**DAC 25/07/23 – 21 PARNELL PLACE NEWCASTLE EAST –
DA2022/00705 – MIXED USE - ALTERATIONS AND ADDITIONS TO
EXISTING HOTEL OR MOTEL ACCOMMODATION (NEWCASTLE
BEACH HOTEL), ANCILLARY FOOD AND DRINK PREMISES AND
COMMERCIAL USE (ANCILLARY HOTEL SPA) AND DUAL
OCCUPANCY (ATTACHED 2 X DWELLINGS)**

PARNELL PLACE

21 Parnell Place, Newcastle East, NSW 2300
LOT 1 /DP815595

DRAWING
 NOTIFICATION PLAN

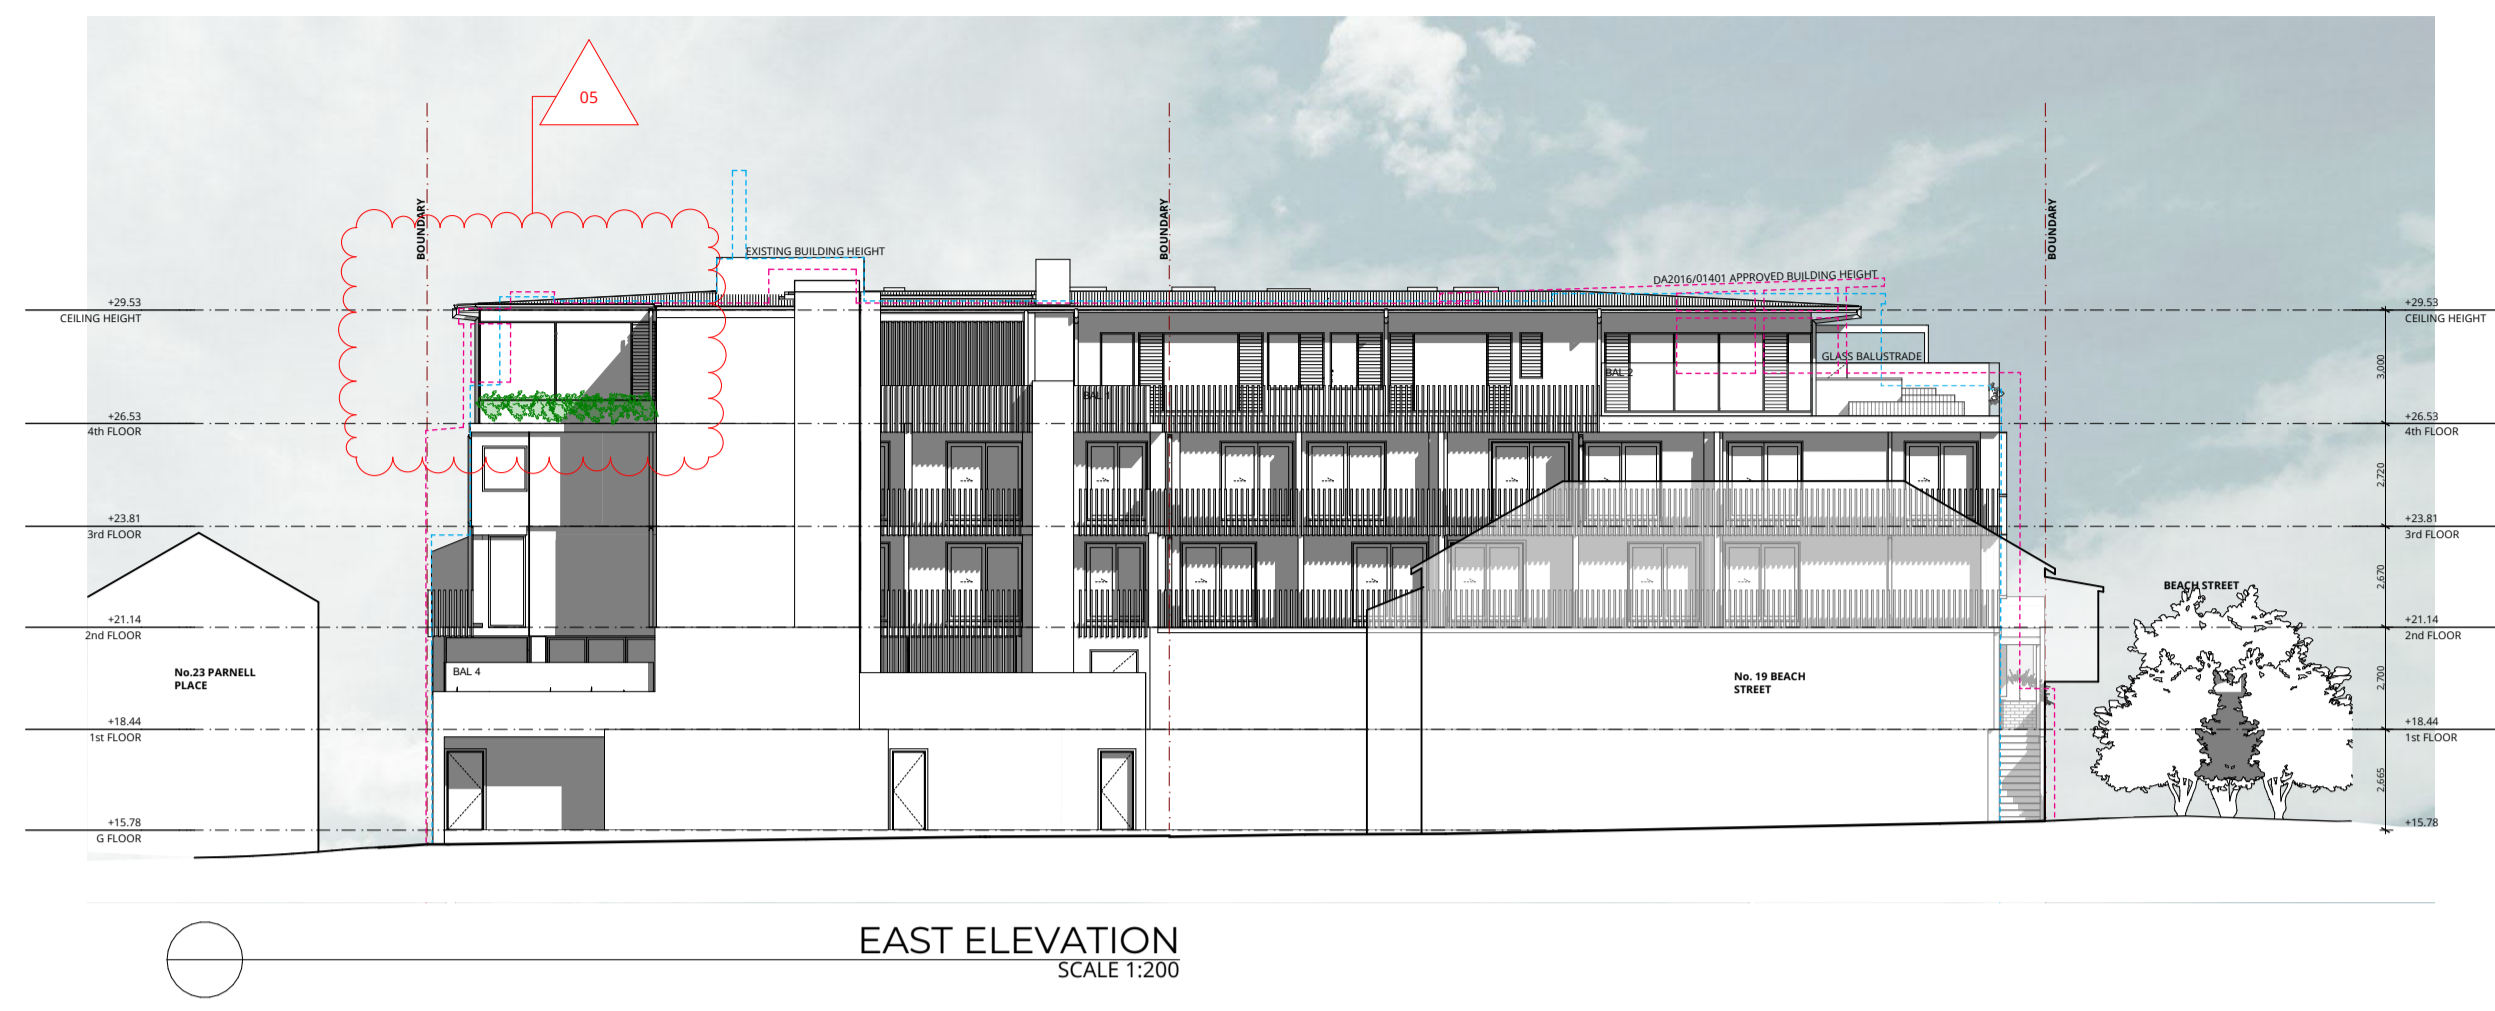
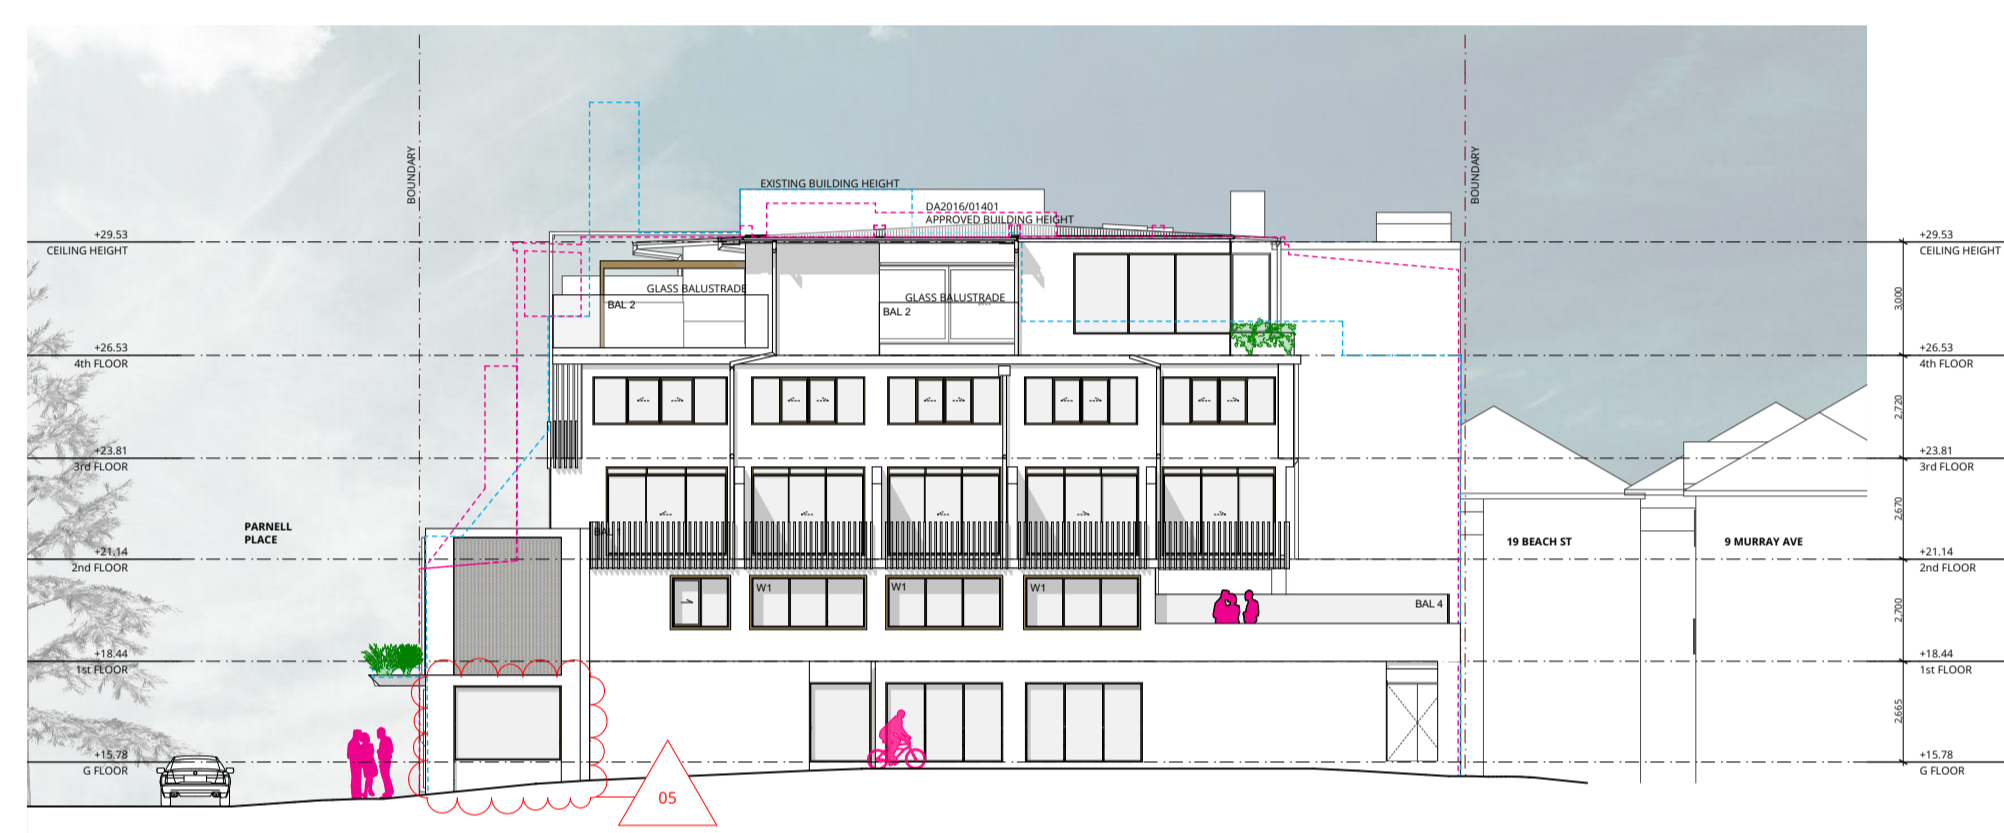
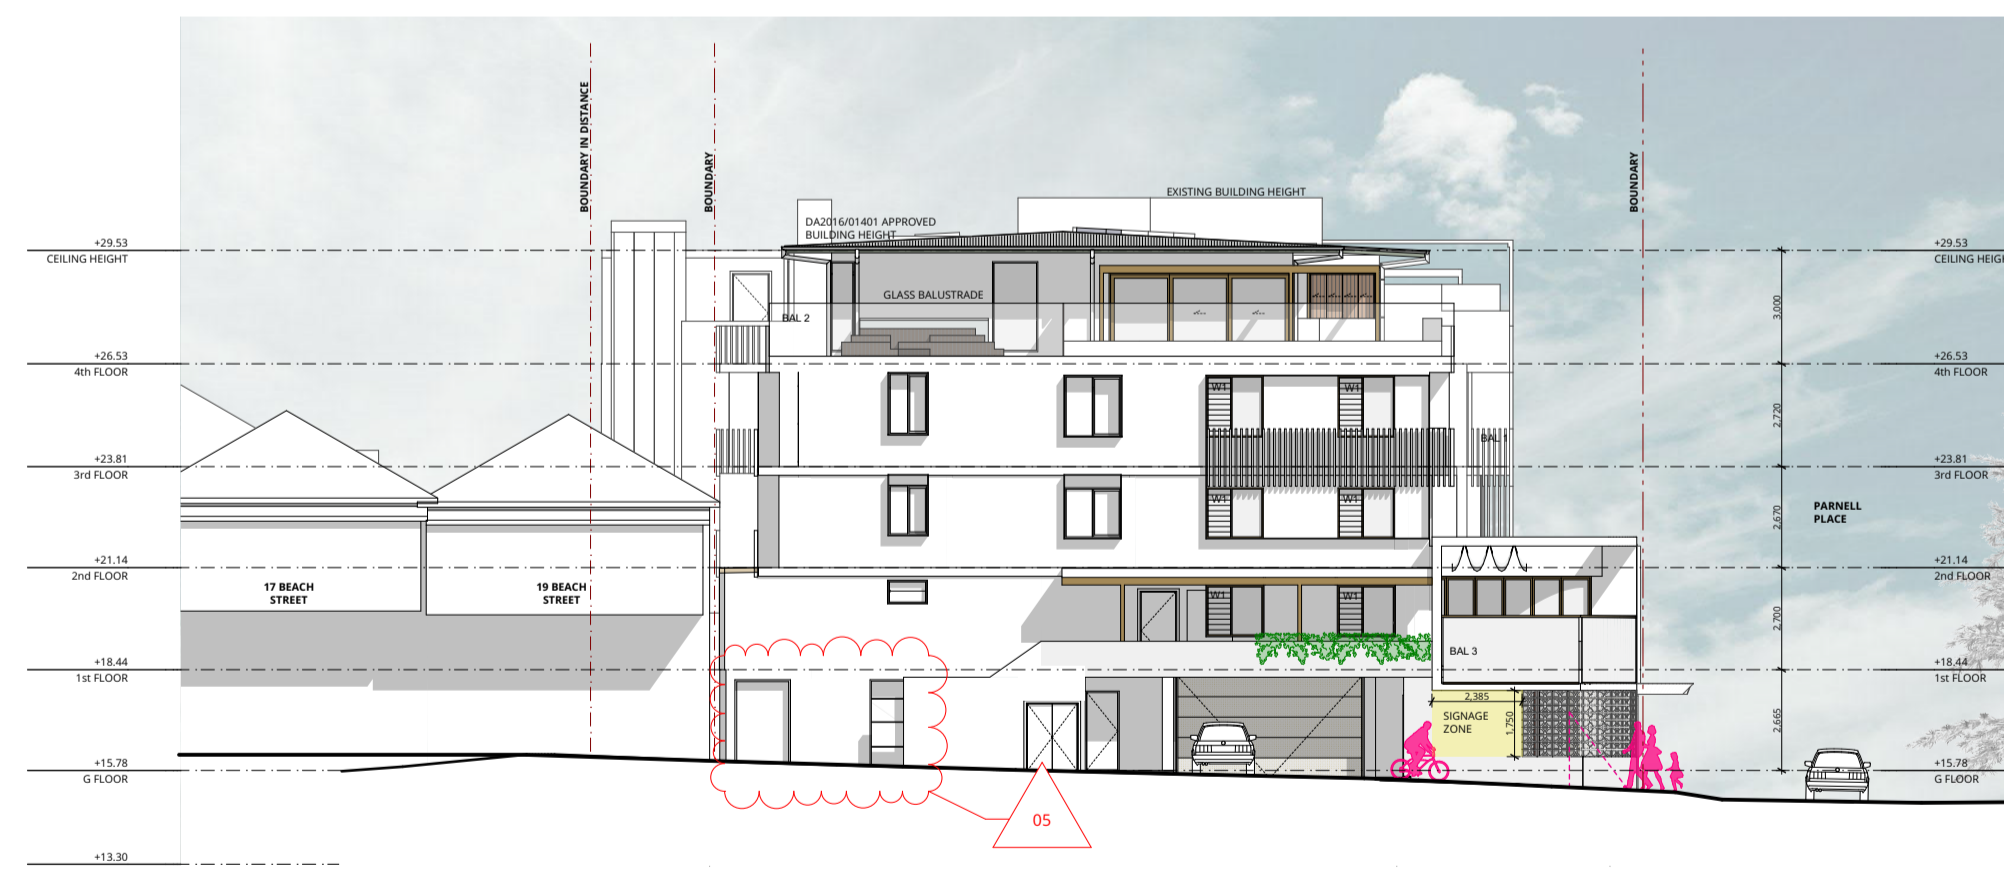
- HERITAGE**
- PENTHOUSE 2 SETBACK FROM SOUTH EAST CORNER BY 1200MM AND LOW GARDEN ADDED TO SOFTEN EDGE AND REDUCE BULK & SCALE
 - EAVE REDUCED BY 600MM TO REDUCE SCALE
 - ADDITIONAL LANDSCAPING TO PENTHOUSE 01 NORTH-WEST CORNER
 - LEVEL 03 SIGNAGE ZONE REMOVED

- WASTE SERVICES**
- BIN AND KEG ROOMS REWORKED TO PROVIDE SPACE FOR MORE BINS, ACCESS DOORS ADJUSTED TO SUIT
